**THURBER** ENGINEERING LTD.

December 23, 2021

**GEOTECHNICAL PEER REVIEW  
GHD GEOTECHNICAL EVALUATION AND REMEDIAL PLAN  
CELL 20-1 SLOPE STABILITY ISSUES  
CLEAN HARBORS LAMBTON LANDFILL FACILITY  
CORUNNA, ONTARIO**

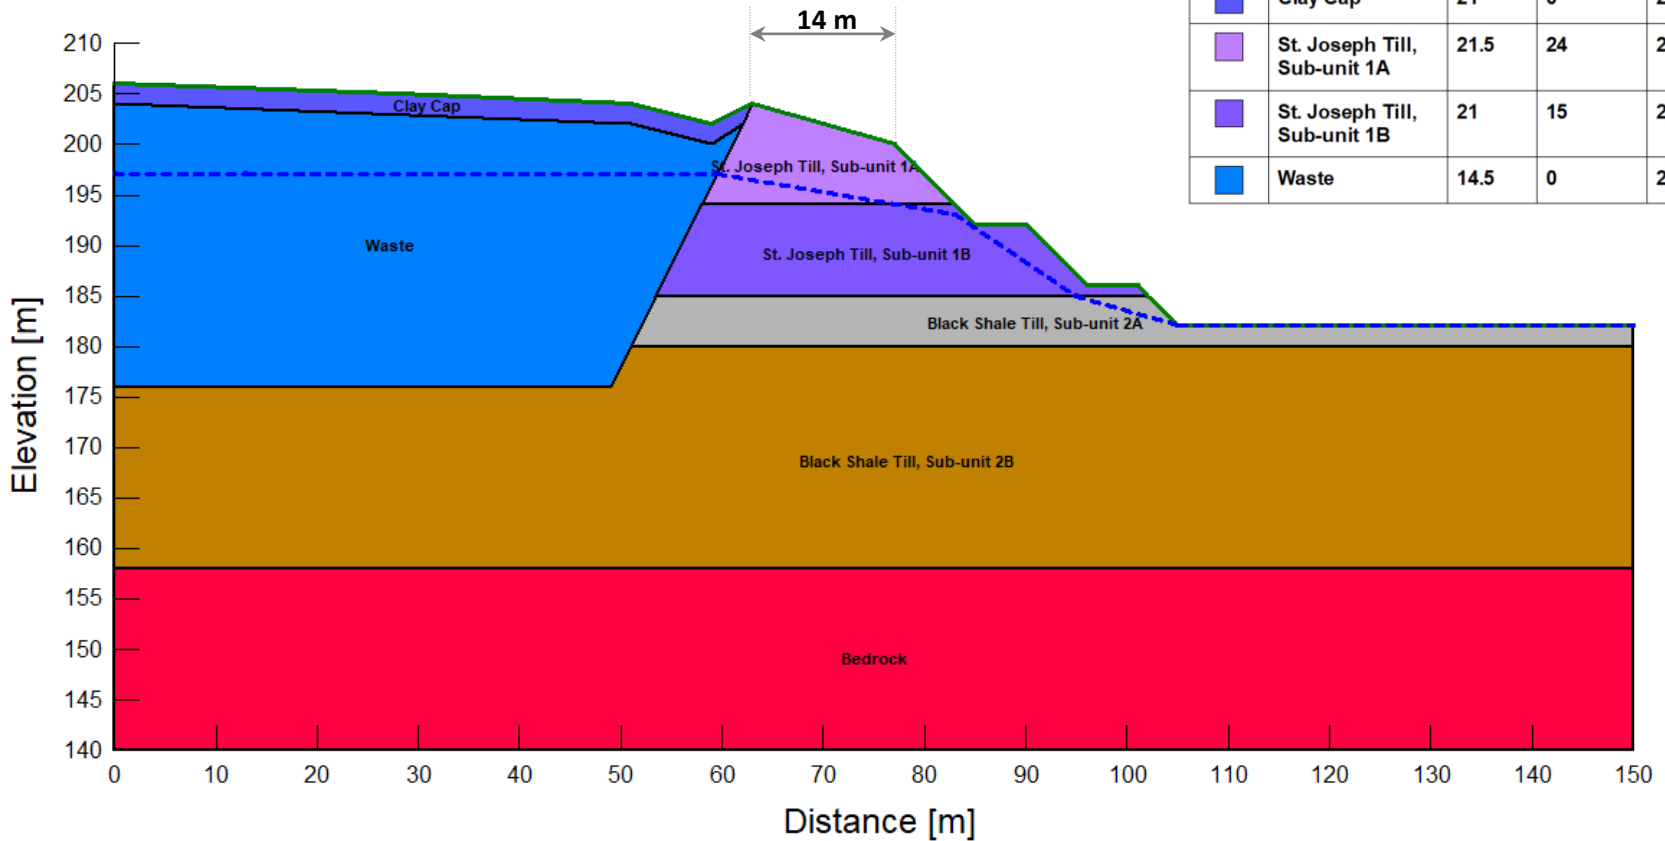
Figure 1 presents the general arrangement of grades and soil units. We have assumed similar grades as presented in the GHD Design Report. We have also used the same lower bound parameters used in the GHD Report, however, have included the bedrock layer which was missing in the GHD assessment. The location and depth of waste fill in the pre-1986 cell is approximated based on available data.

Ignoring Bedrock  
Artesian Pressure

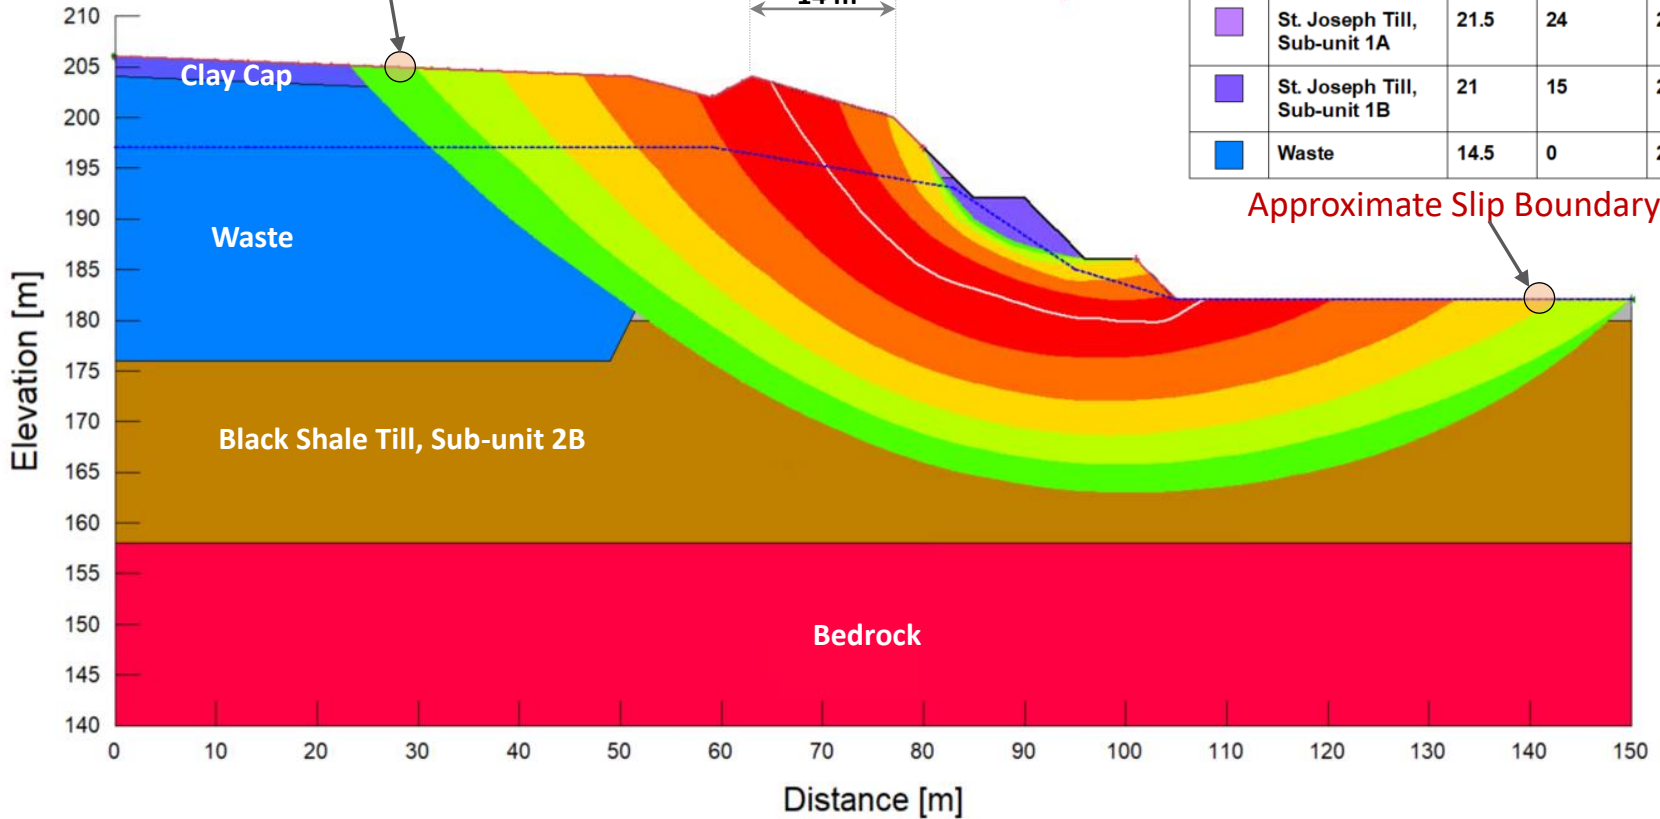
Figure 2 presents the results of the failure model without considering hydrostatic uplift from the bedrock aquifer. The minimum factor of safety (FOS) is 1.04, which is below the design target of 1.3.

**Figure 3**

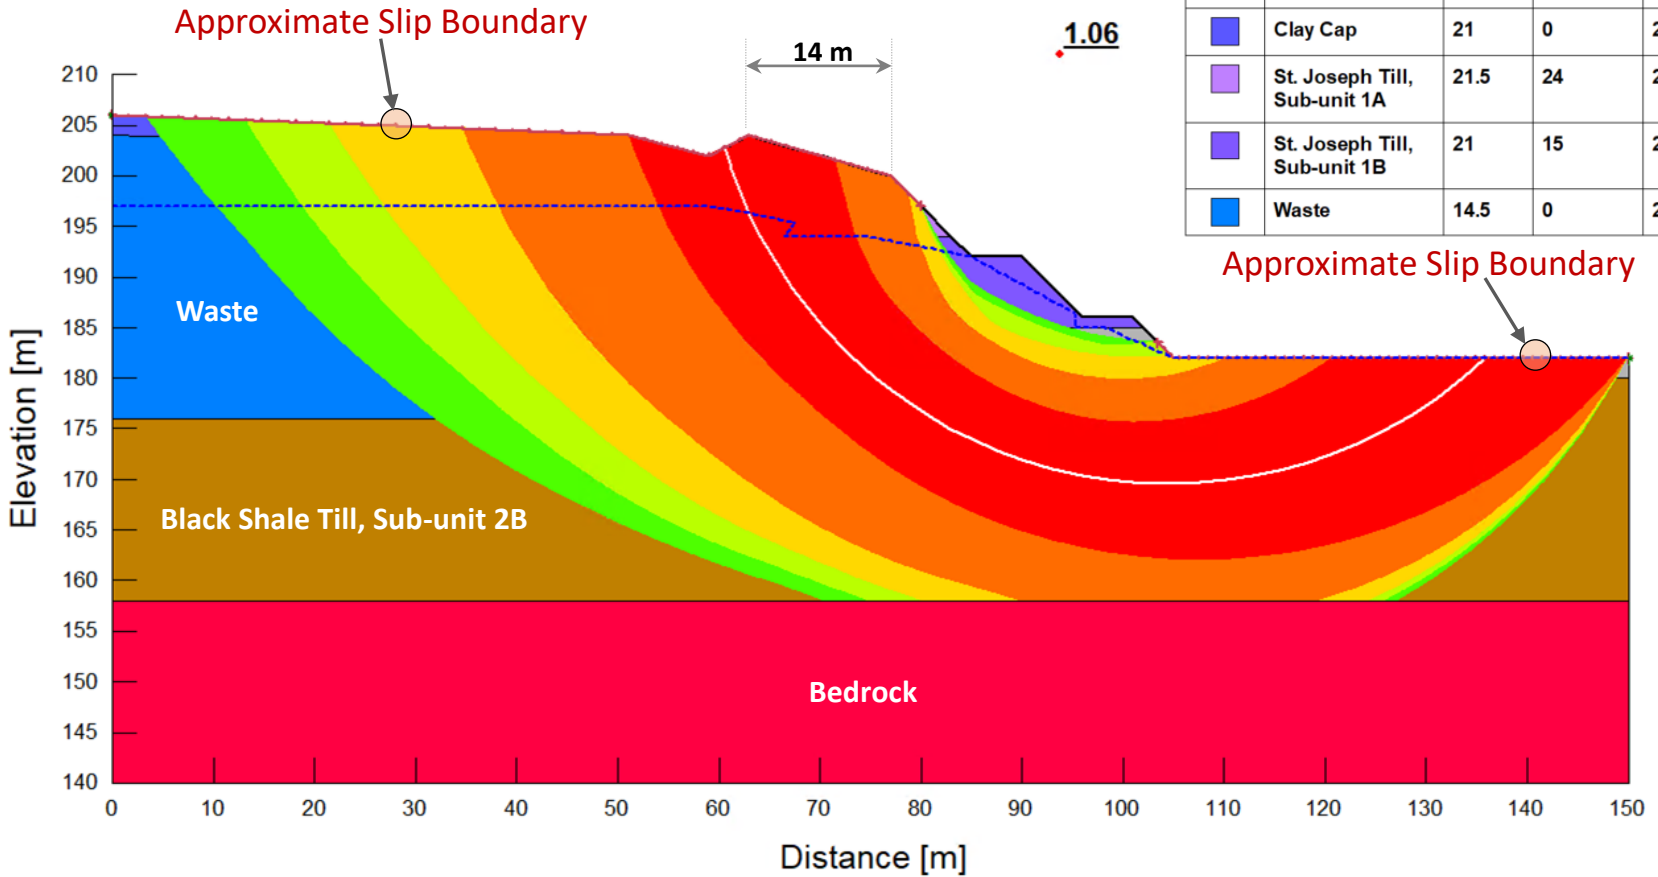
Figure 3 presents the further effect of uplift for the hydrostatic aquifer. The minimum FOS is 1.06. More important, the modelling shows that the assessment of the ground conditions using the hydrostatic uplift presents a possible failure scenario which is similar in extent as the actual event. Overall, this modelling shows that the failure surface selected by GHD may not be correct. We recommend that GHD complete further stability assessment assuming at least two additional deeper failure surfaces.
